Interactive comment on "The influence of reservoir traits on carbon dioxide emissions in the Belo Monte hydropower complex, Xingu River, Amazon – Brazil" by Kleiton R. Araújo et al.

Kleiton R. Araújo et al.

Received and published: 24 May 2019

Fig. 3. Fig.4

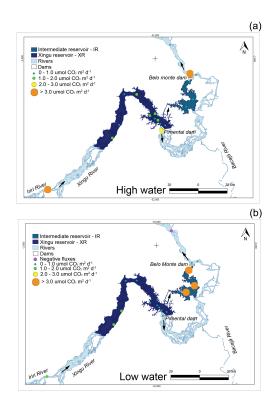
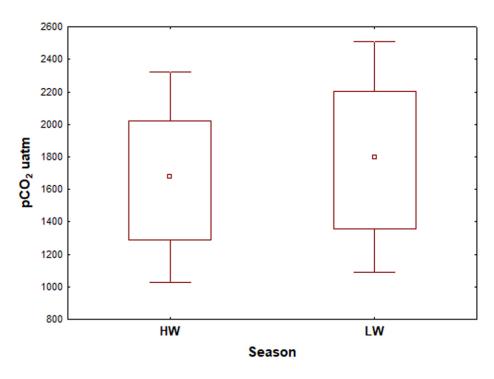
Figure 3. In panels c and d, I would suggest you order the environments in flow direction. That is, upstream first then XR environments, then IR environemnts, then downstream. If it gets too crowded, make two separate panels for high and low water. And the same for pCO2 and FCO2 and k600, i.e. you may end up in 6 panels instead of 2. Together with panels a and b, it would be 8 panels.

Figure 4. When seeing this figure, I wonder how much of this spatial variability is driven by differences in pCO2, and how much by differences in k.

Response: We have reordered and changed the categories. We added the cate-C15

gories in the following order: "unaffected river upstream", "XR", "IR", "downstream of the dams" and "unaffected river downstream". Panels were also separated by season.

Response: To make the spatial variability more visible we have added one more panel related to k600 to figure 3.
